Whale Tail 2025 Annual Open Pit Geomechanical Inspection Report

March 10, 2026

RE: Meadowbank Complex - Amaruq Site - 2025 Annual Open Pit Geomechanical Inspection

Observations - South Wall

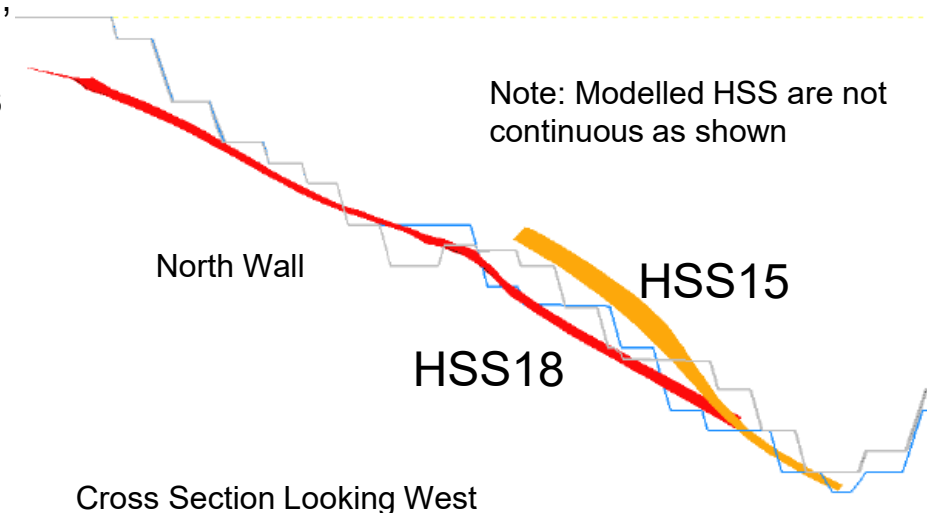
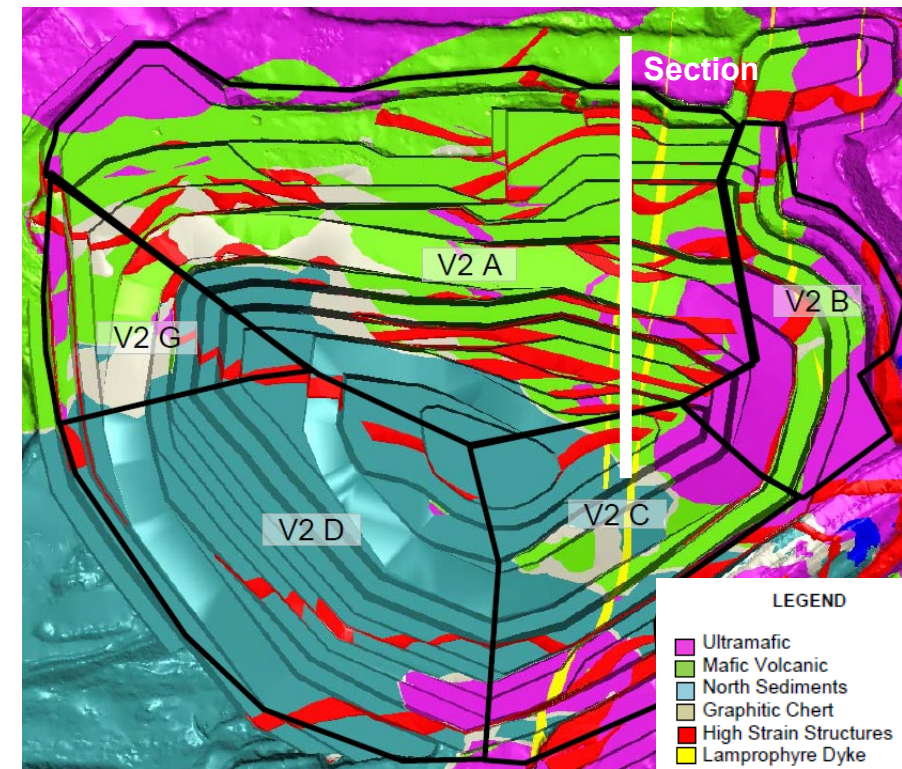
- The rock mass quality and rock mass structure in this wall are generally favourable and the performance of the initial bench has largely been consistent with expectations.
- However, a large potential wedge was identified in the initial flitch during mining and was proactively scaled out. Several smaller wedges formed by the same structures are present directly to the east of this area, at the crest.
- The joint sets that formed the wedge have not yet been confirmed. The sub-vertical set forming the eastern limit of the wedge may be Joint Set D while the shallower dipping set forming the western limit of the wedge may be Joint Set B. This should be confirmed and compared relative to the results of the stability analyses completed for this wall. If these features are more prominent than originally thought, the bench design may need to be adjusted.

Hazard / Risk Assessment

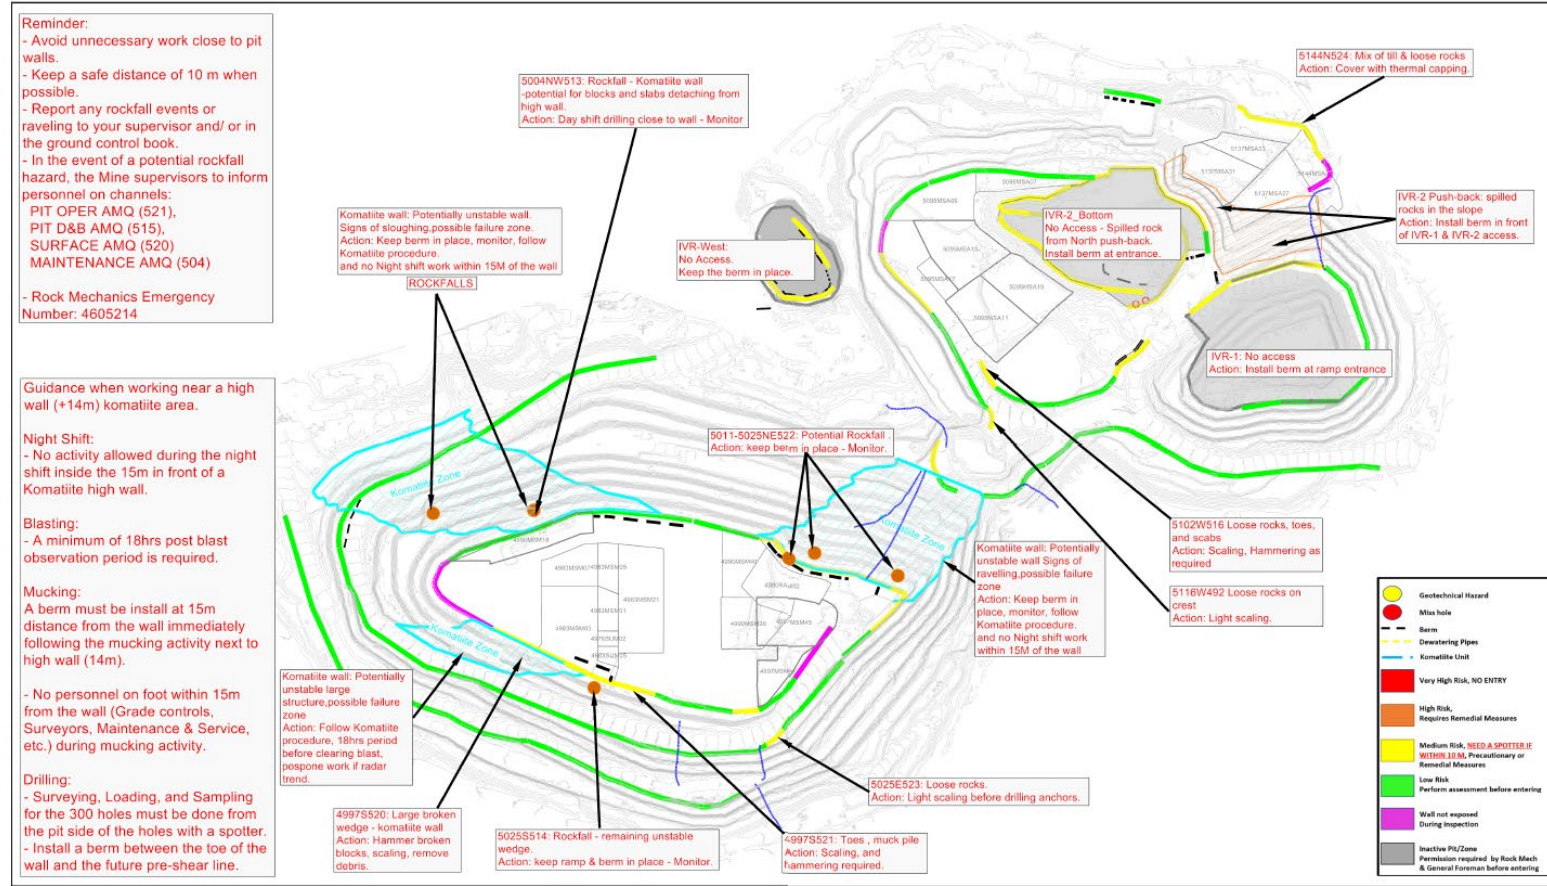
- Identified hazards and the required mitigation work are tracked on a Hazard Map available to the workforce that is updated every two weeks.
- Comments on the maps and their integration with work near the pit walls is provided on the next slide.
- There continues to be limited guidance on how to select the risk ratings. However, only two AEM personnel complete the maps and they feel that they use a similar approach. Recommend developing more detailed guidance in the event of a change in personnel.
- The hazard map has been updated to show the location of the Komatiite Zones (which trigger the Working With Komatiite procedure) and the position of berms. Green Candles are also used in the pit to demarcate geotechnical hazards. These are positive developments.

Sub-Surface Monitoring (Cont'd)

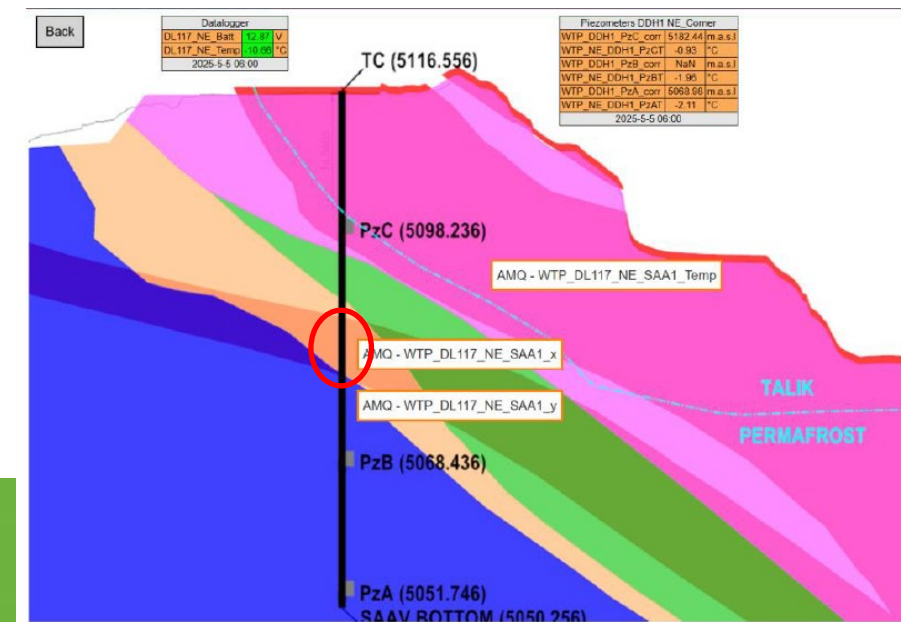
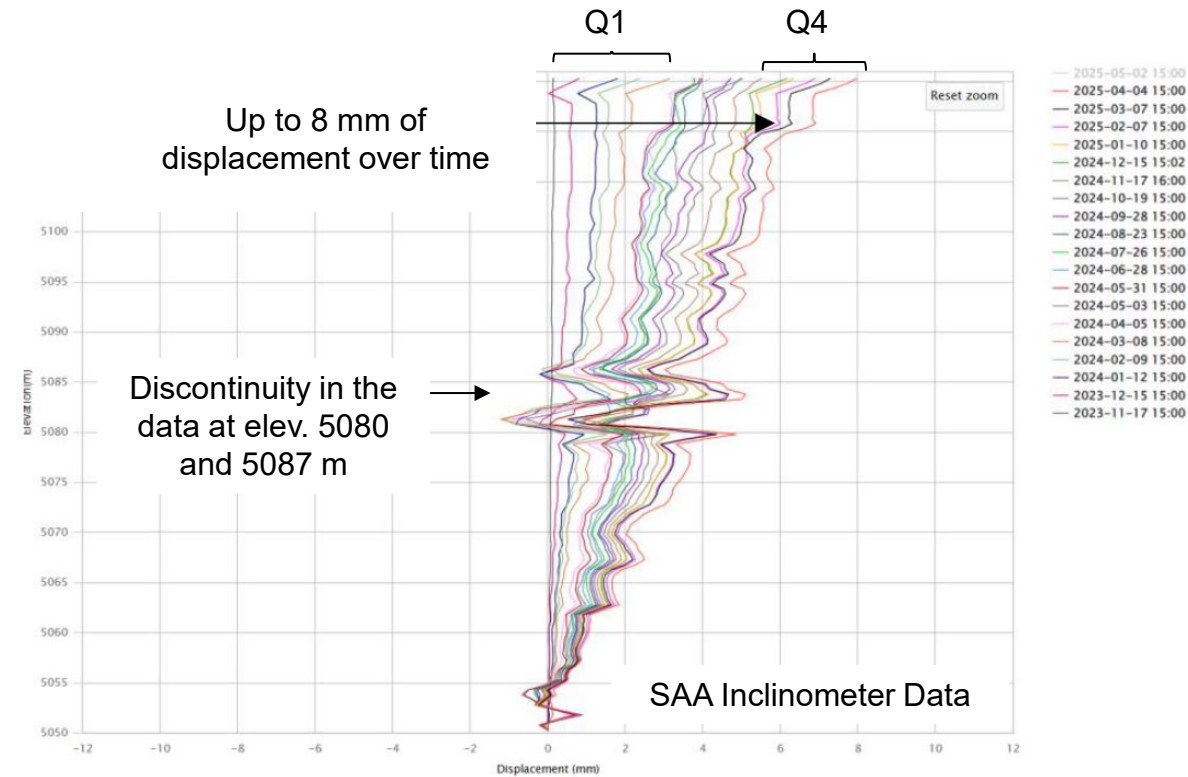
- The data from the SAA installed in the upper Northeast Wall of the WHL open pit are shown at upper right.
 - There are peaks in the data at elevation 5080 and 5087 (roughly the area circled in red at bottom right). These correspond to a contact between the Greywacke (blue) and the Chert (orange).
 - A high-level review of the data suggests that the displacement increased when mining was occurring at the toe of the slope in Q1 and Q4 2024. Recommend plotting the data relative to mining activities in this sector.
-
- All of the instruments are integrated into the mine's monitoring system (e.g., MonitorIQ). Trigger thresholds, alarms, and a TARP need to be developed for the SAA to govern the management and interpretation of the data.
 - Additional instrumentation should be installed as mining progresses (e.g., Design Sector A1K and IVR V2 Design Sector V2A).
